MEETING OF JULY 19, 2011

Application I.D.: 2011-0017

Application Type: Single Family Design Review

Location: 1731 Valley View Drive

2. RESIDENCE FOUNDATION WORK:

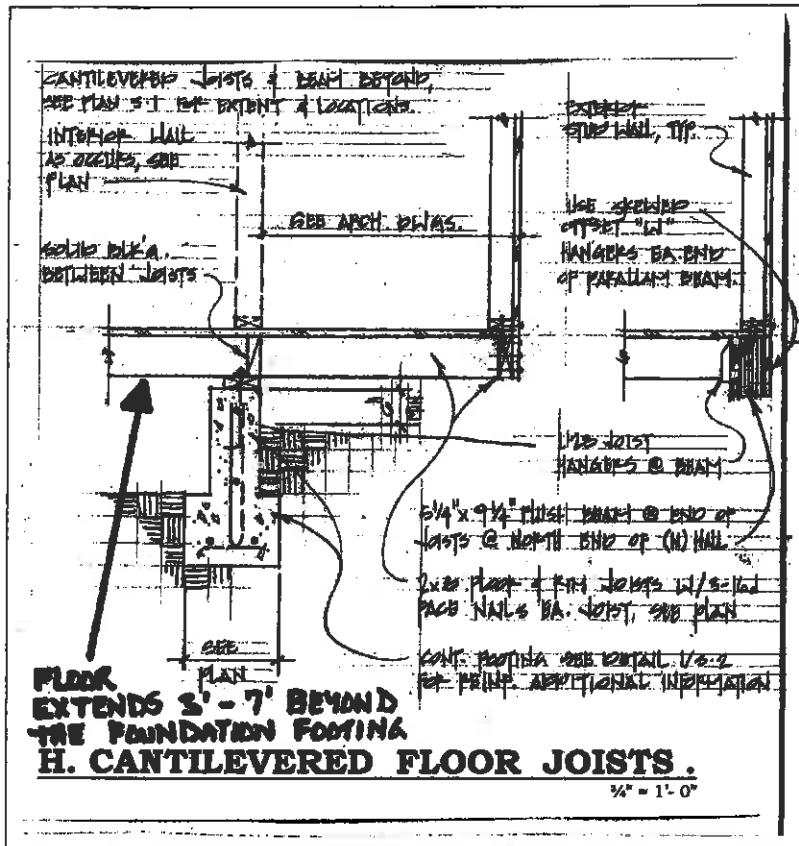
Best Option for oak #38: If possible, avoid all pier drilling work around oak #38 (and #37) by using an alternative "cantilever type" foundation for the residence addition (see sample spec sheet below). It may be possible to extend out laminate beams and/or steel beams from the existing concrete foundation such that the new addition is essentially floating above grade with no drilling or other soil grading required between the existing foundation footing and the oak trunks. If the existing foundation is structurally sound, I highly recommend leaving it as-is, since removal of this footing will cause damage to oak #38 and require a full rebuild of a footing near oak #38, causing further root damage which will likely result in the decline and premature death of the tree.

9 Tree Map Scan

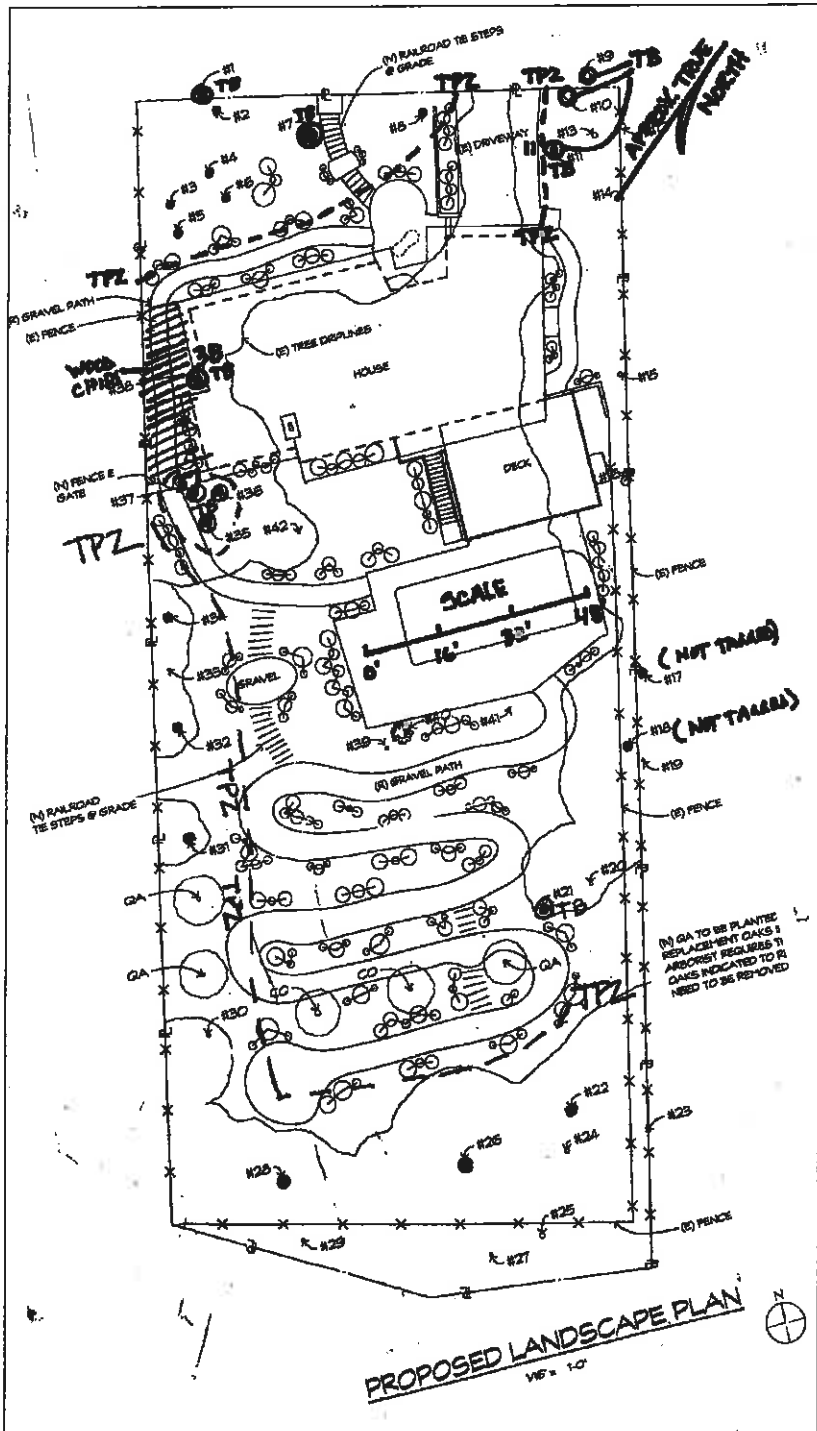
The tree map scan is a marked up version of applicant sheet 1.1 dated 2/22/2011 by Jason Kaldis, Architect of Berkeley, California. The architect plotted approximate tree canopy dripline dimensions on this sheet which were fairly accurate. The contract city arborist (CCA) added proposed tree protection zone fencing routes and other notes to this sheet such as "TB" indicating that a trunk buffer will be required.

To mitigate site plan work related soil compaction over the root zones of oaks #37 and 38, install a 12 inch thick layer of high quality chipper truck-type wood chips over the open soil root zone area between the existing wood property fence (west side property boundary) and trees #37 and 38 per the hatched area on the tree map in this report.

Note that the author's TPZ fence routes essentially force the site plan to be revised such that the walkway is pushed farther away from rear yard trees, access is restricted to only the west side of the site since there is a solid TPZ blocking the east access to rear yard, and the main front yard oak grove is completely fenced off such that there will be no access until the end of the project when the railroad tie stairs can be installed during landscaping.
